Department of Energy Responses to the Nuclear Regulatory Commission Request for Additional Information on the Draft Waste Incidental to Reprocessing Evaluation for Vitrification of Low Activity Waste

**Department of Energy Responses to the
Nuclear Regulatory Commission
Request for Additional Information on the
Draft Waste Incidental to Reprocessing
Evaluation for Vitrification of Low Activity
Waste
(Revision 1, Consolidated Response)**

July 2021

Figure 2-3-1. Two-Dimensional Vertical Cross-Section Model of Integrated Disposal Facility Showing Numerical Grid and Surface Barrier Materials.

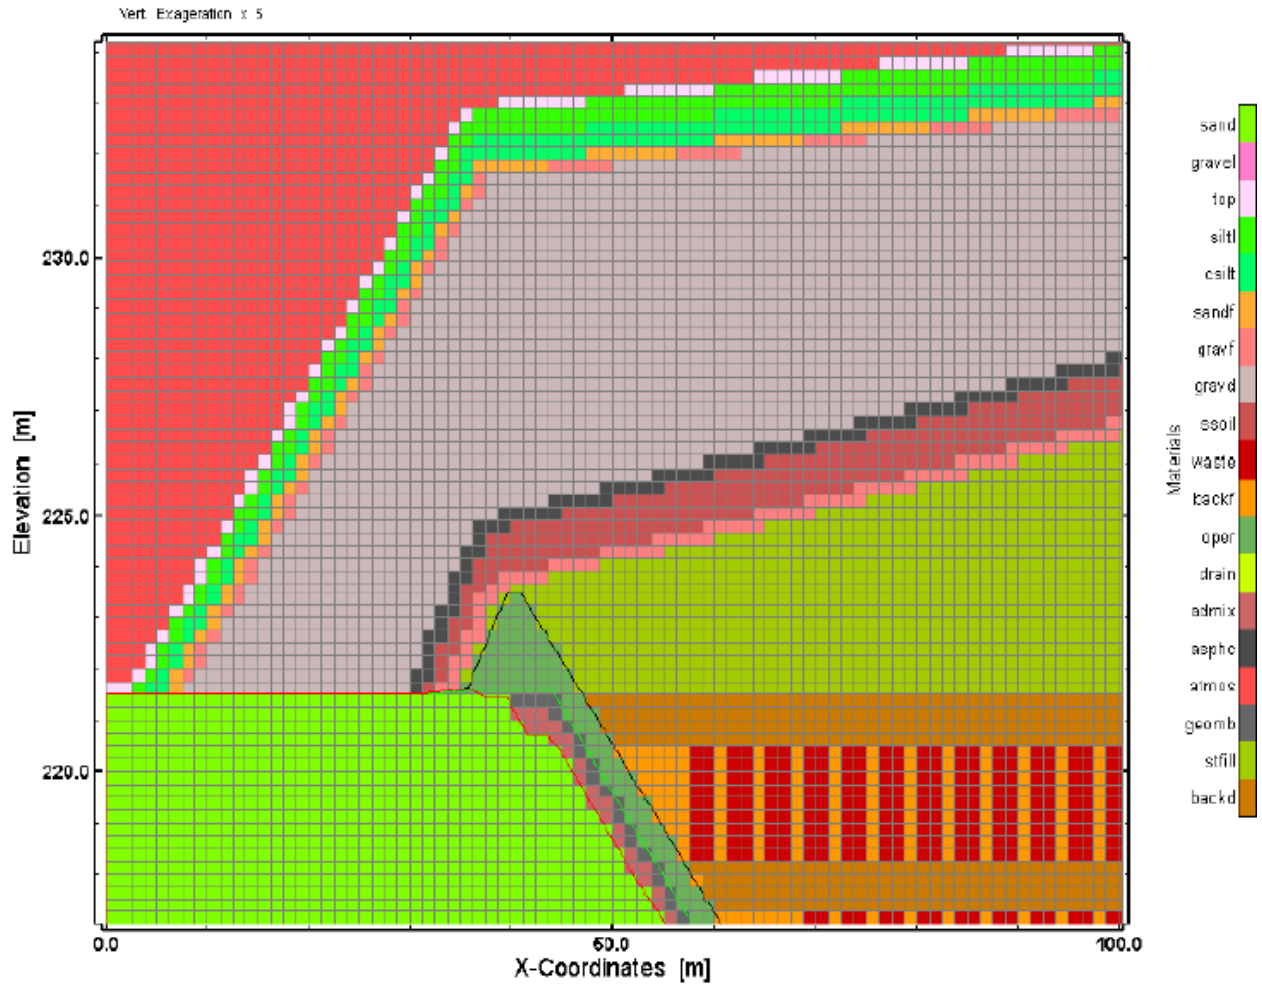
Figure 4-22 from the PA document (shown below), provided the numerical grid and material properties assigned for near-field flow. It appears that some layers are not continuous in the model. It is not clear how the discretization was fine enough to ensure proper precision. The text of the PA document describes the stair-stepped discretization but does not explain how it was determined that the model discretization was sufficient. The potential impact is shown in Figure 5-11 from the PA document (partial figure provided below) where the saturation values and liquid flux rates appear to have large variations as a result of the numerical grid selection.

DOE acknowledges that the discontinuous layers of the engineered surface barrier in the two-dimensional (2D) near-field flow model depicted in RPP-RPT-59958, Figure 4-22 do not physically represent the continuous layers that would be constructed in the barrier above the IDF. The discontinuous nature of the model layers in the surface barrier are a result of the selected grid size used to represent the engineered surface barrier, but DOE believes that the grid size was adequate for the intended purpose of the model, which was to investigate moisture distribution in the vicinity of the waste containers and through the IDF liner system. The simulation results were then used to develop boundary conditions for radionuclide fate and transport simulations; the near-field flow model was not used to simulate radionuclide fate and transport.
